## **STAFF MEMO**

**Date:** June 8, 2021  
**To:** Town of Milford Planning Board  
**From:** Jason Cleghorn, Town Planner  
**Subject:** **SP2021-04 Crosby Townhomes, Kling/Mengyuan Property Management, 159 Elm Street, Map 19, Lot 5.** Public Hearing for a major site plan application to construct a six (6) unit townhouse, multi-family residential project with related parking, drainage/stormwater management, landscaping, and lighting improvements.

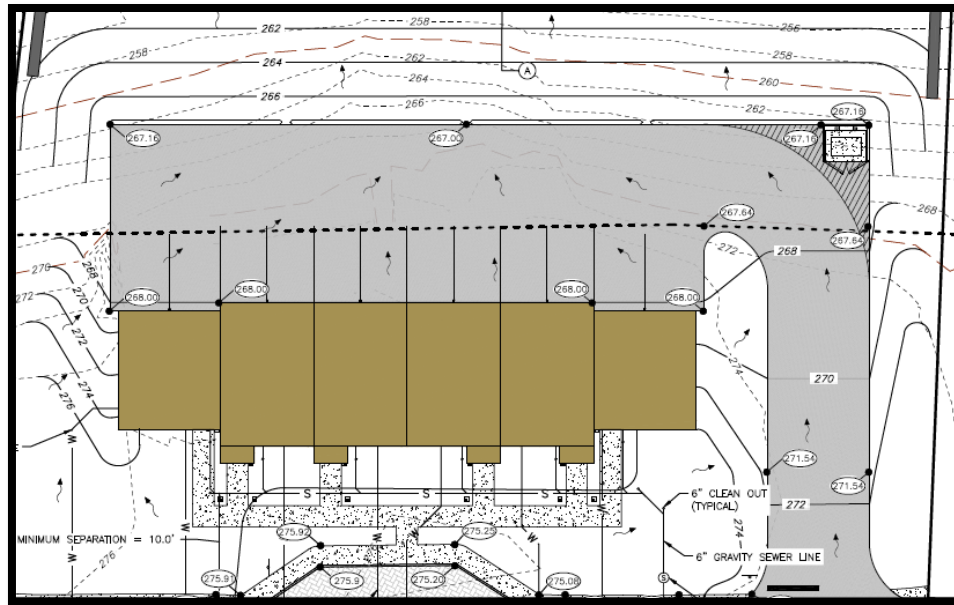
1. Elevations: Per § 6.04.2 of the Development Regulations, plans shall show all building elevations. The submitted elevation is only 1 view of 4. Please include the other three elevation views. While the parking is located in the rear of the building, the Town would still like to see these additional elevations. Staff may have additional comments pending the receipt of these elevations.

Proposed Elevation from Elm St. looking north

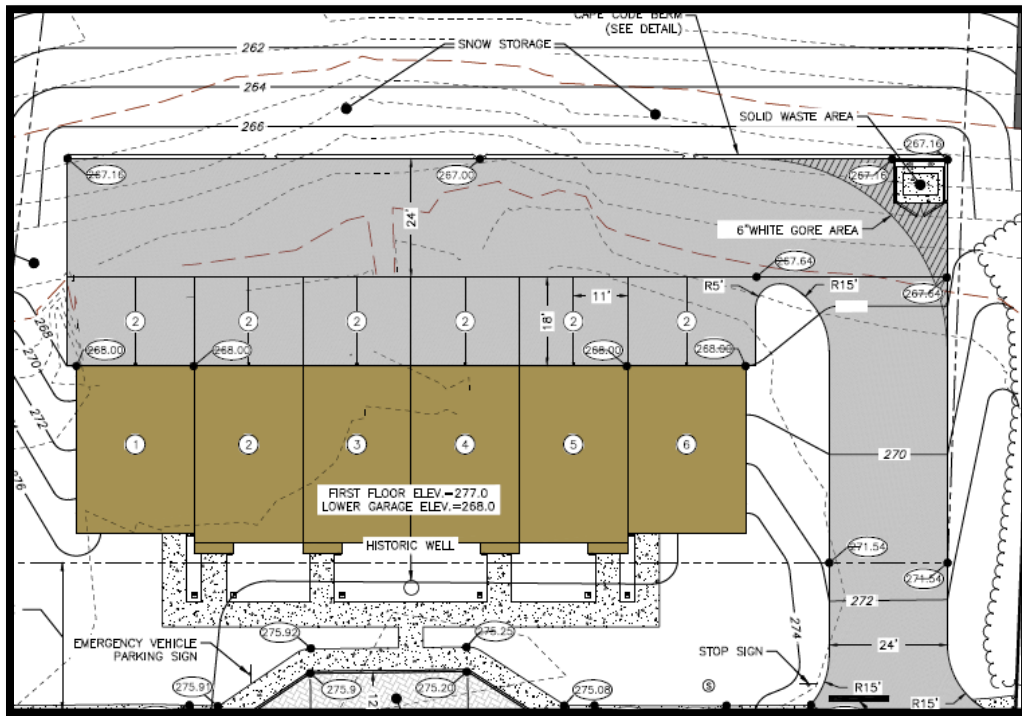
There have been minor changes to the building plane since the last iteration of the site plan. The front plane of the building has less articulation and presents in a flatter manner. Staff has requested elevations for the other three sides of the building as part of its final review of the plan.

Original Submission with Stub-out and Articulation

Revision with minimized stub-out and articulation (flatter plane)
